Road Safety Audit Review

Town:	Highgate	Date Reviewed:	January 19 2016
Route:	VT 78 @ Machia Road	Mile points:	VT 78: 6.76

The location of this RSAR is the intersection of VT 78 and Machia Road in Highgate.

FILE NAME: s98j378bdr.dgn
 PROJECT LEADER: D. BONNEAU
 DESIGNED BY: D. PETERSON
 LAYOUT SHEET 1

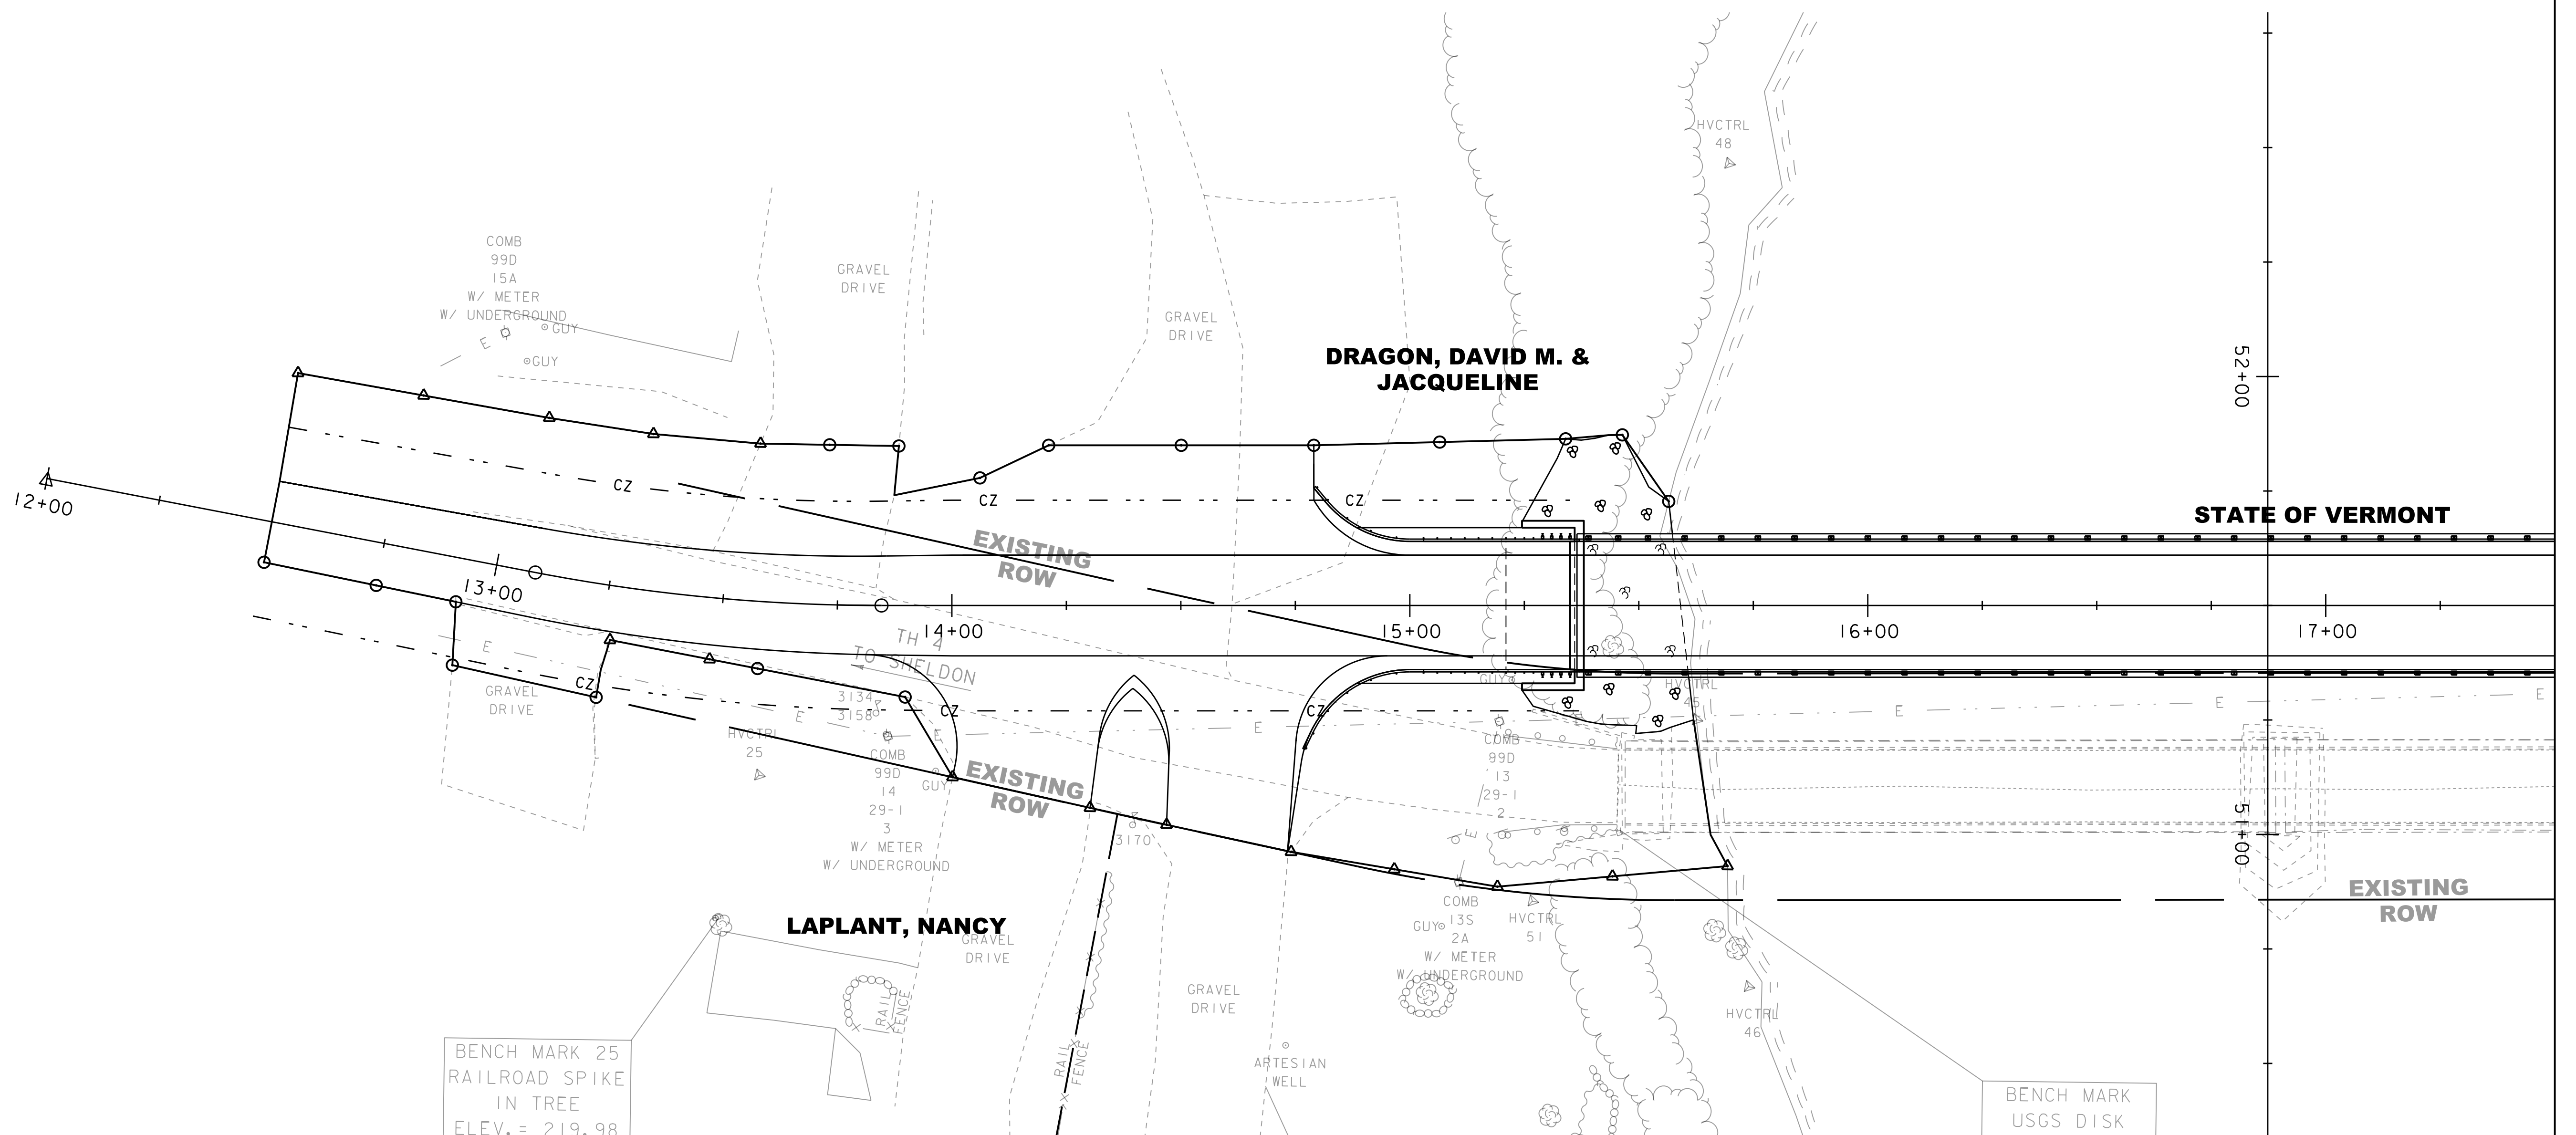
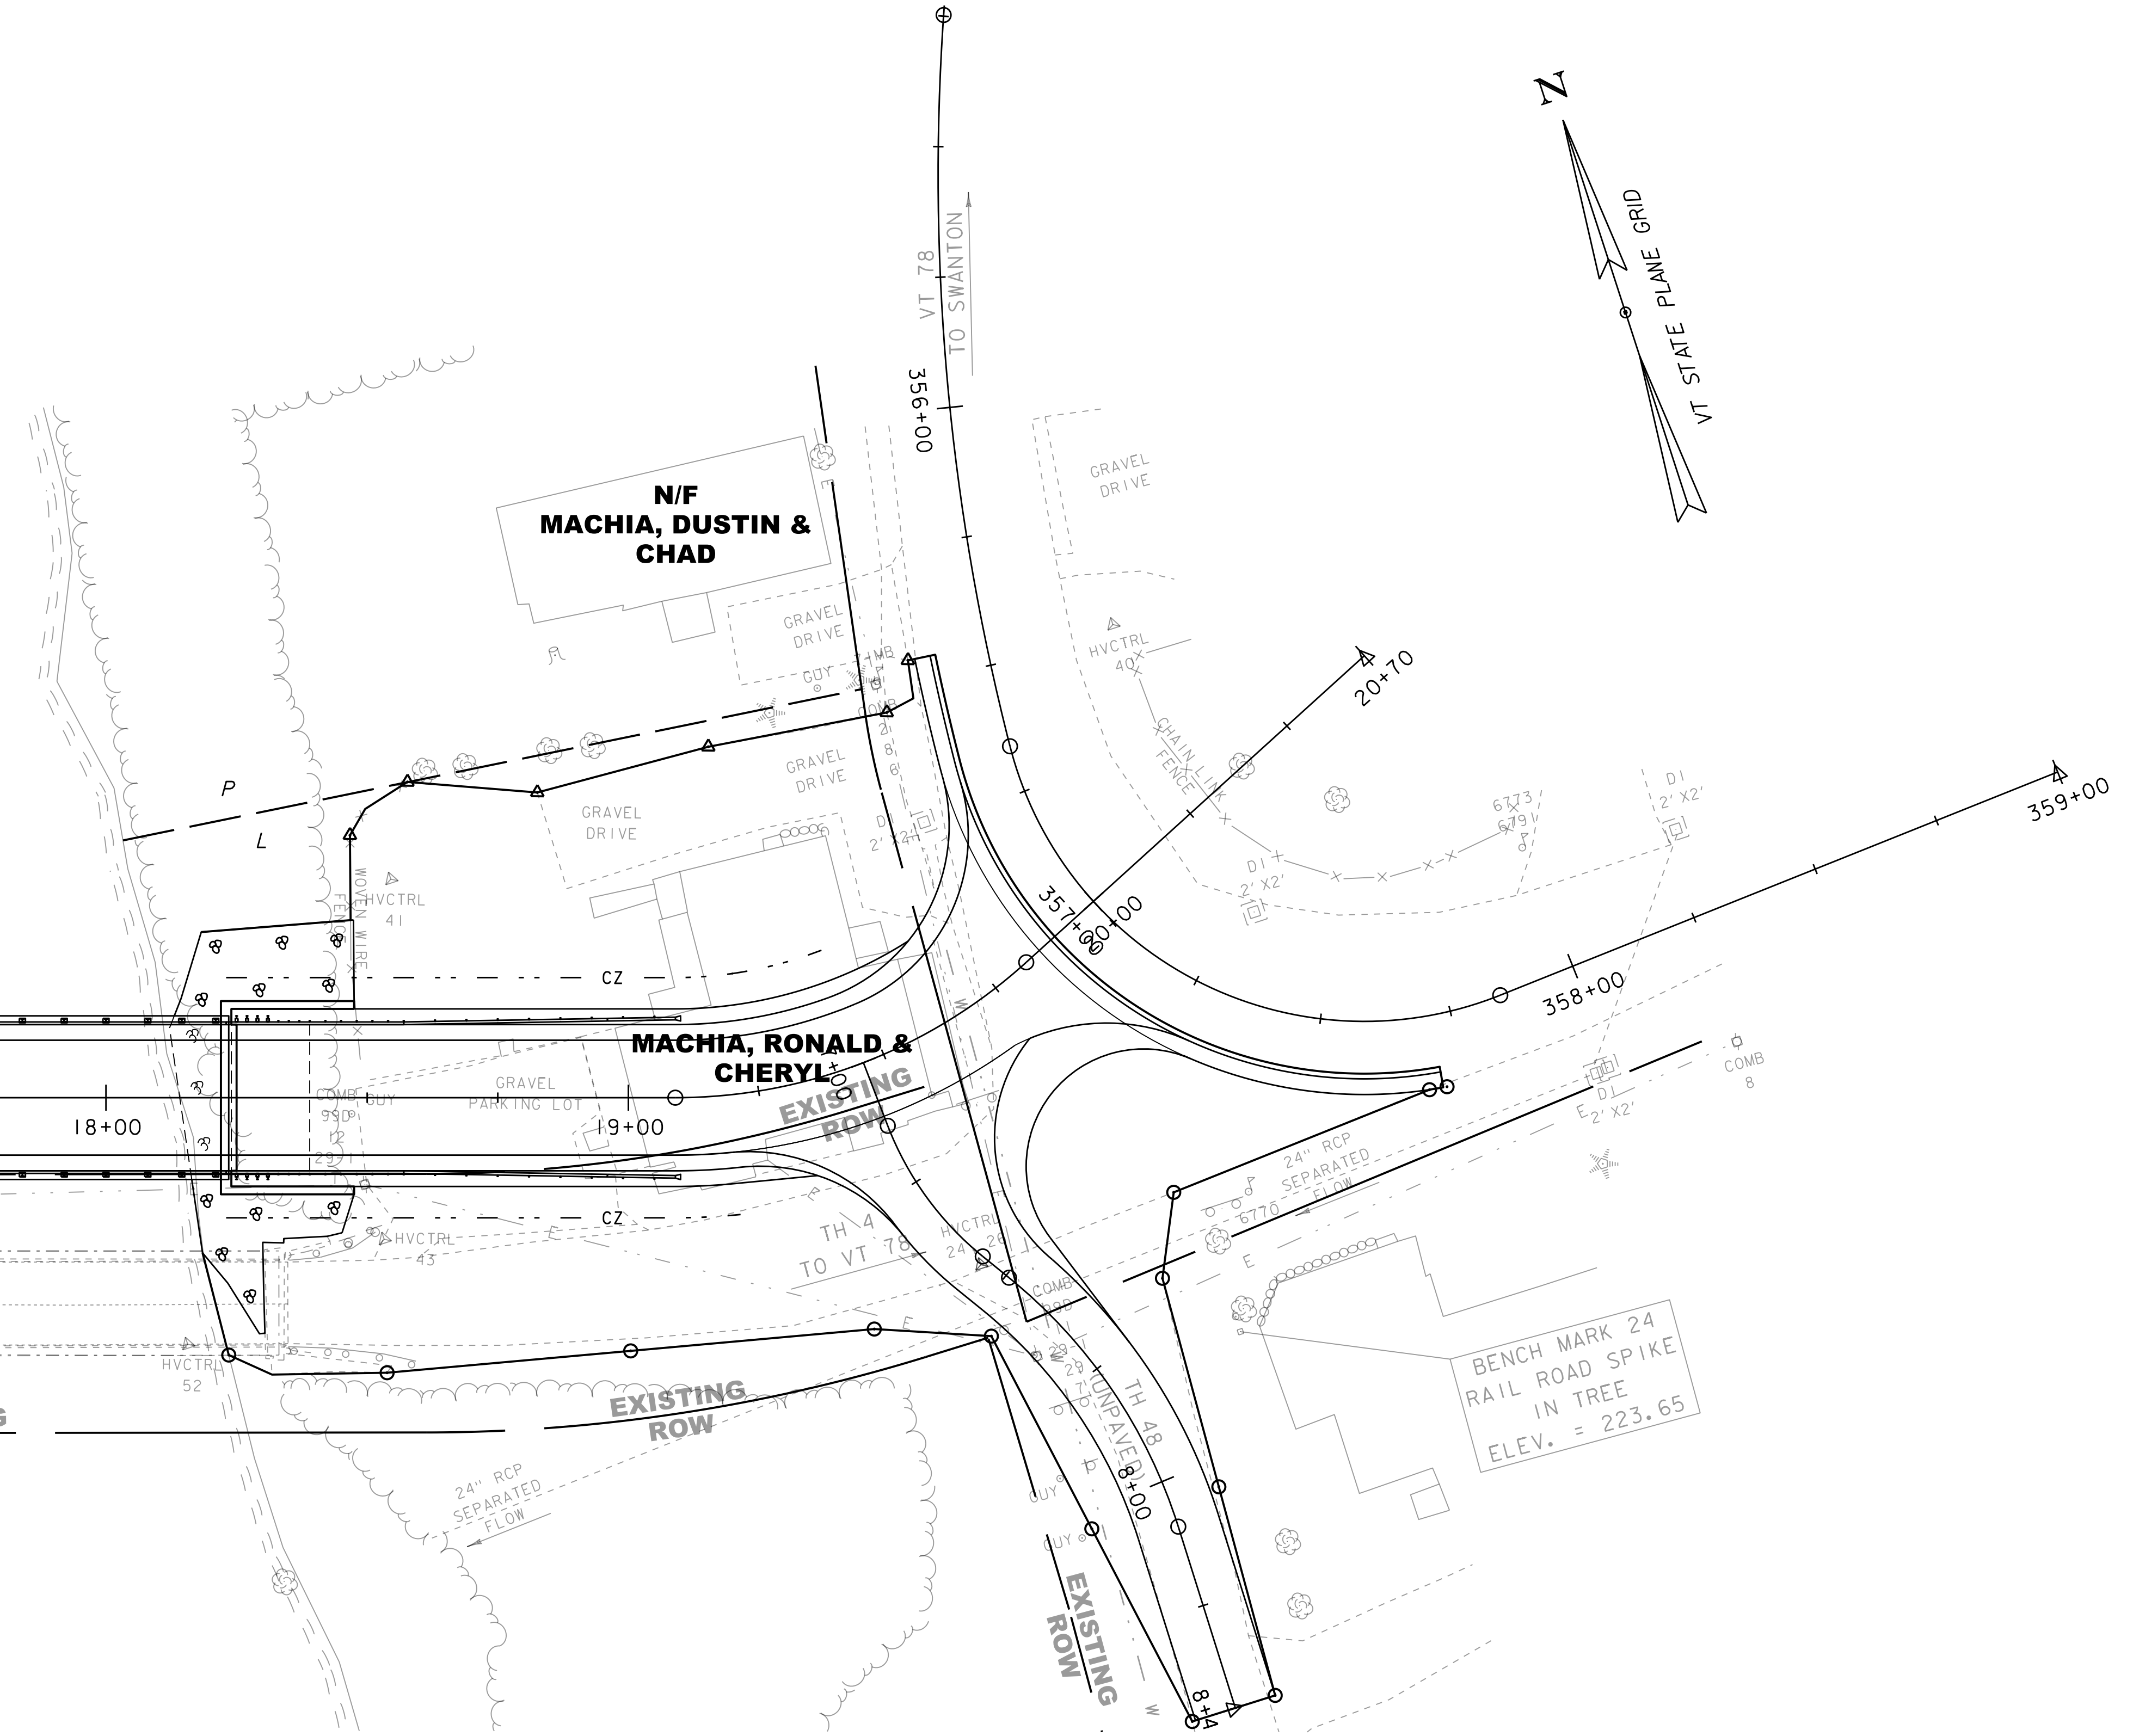
Relocate Machia Road on a new alignment that would go through the property at 6756 VT 78 as considered by project BO 1448(43). This would force motorists to make a left turn at about a 90 degree instead of shooting straight. The available sight distance for making the left turn onto Machia Road on a new alignment would be approximately 230-240 feet.

Pickup trucks with livestock trailers need to be able to see oncoming traffic in advance in order to be making their turn. The house (# 6756) prevents the operators of these vehicles from seeing traffic coming off the bridge.

The removal of the house and associated relocation of Machia Road on a new alignment through the property as considered by project BO 1448(43) would resolve this condition.

Realign Machia Road on a new alignment that forces motorists to slow down before approaching and entering VT 78 as considered by project BO 1448(43).
